GENERAL COMMENTS:

The manuscript by Martin Austin et al. presents new observations of the hydrodynamic conditions inside a tidal wake behind an offshore wind turbine monopile in comparison to undisturbed conditions. The measurements took place at an offshore wind farm in the Liverpool Bay and provide valuable insights into the turbulence production caused by the underwater drag of wind turbine installations.

Figure 1:

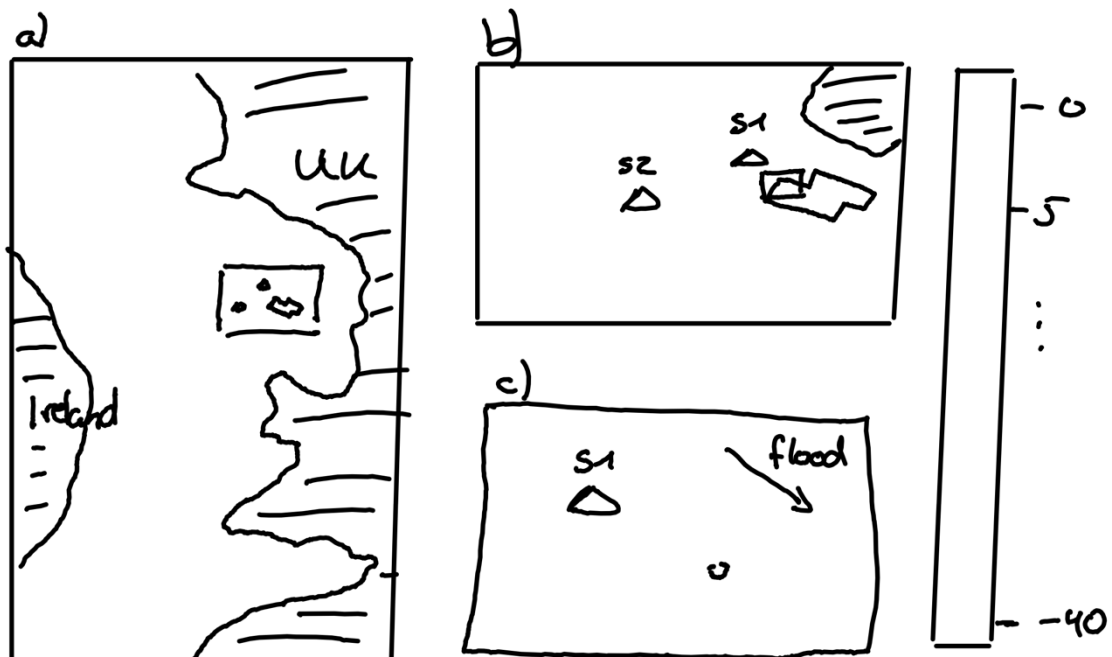
- Figure 1: I think there is an overload of information on just two panels and still geographical information is missing in my opinion. Please revise this figure to highlight all these important information more clearly. (1.) Add another panel/inset to show the geographical area we are looking at. Zoom out to show the Irish Sea and eastern UK coastlines for readers who are not familiar with Liverpool bay. (2.) Indicate the location of the offshore wind farm on your map, e.g. by drawing a polygon. This does not become clear by just looking at the bathymetry. (3.) Plot both measurement stations on the large panel and use the same color (red). (4.) Use lat/lon coordinates. (5.) My suggestion: Instead of using one large panel for the map with an inset for the zoom, split this into three sub-panels showing (a) the geographical region, (b) the zoom on Liverpool bay with the polygons and markers for the wind farm location and measurement stations (bathymetry in the back), and (c) the zoom onto the single turbine plus the measurement station. You could arrange this by plotting the "geo region" panel on the left and the two "zoom" panels on the right (top and bottom), which gives you a nice overview about all three panels and all important geo

information. You could add your panel (b) below as the new panel (d), or to take some load of this figure, plot it in an additional figure, where you plot (a) the velocities and (b) the histogram. This would also enlarge the histogram, which makes it easier to read and easier for you to indicate the critical Reynolds regimes. Also see my drawings in the attached PDF. [We thank the reviewer for their suggestion for a revised version of Figure 1. We have modified the figure, broadly as suggested, and feel that it now provides greater clarity for the reader.](#)

- Figure 1 Caption: remove "..., and indicating the flood tide direction.". This does not really become clear to me by just looking at the bathymetry and is better shown in b). [Changed.](#)
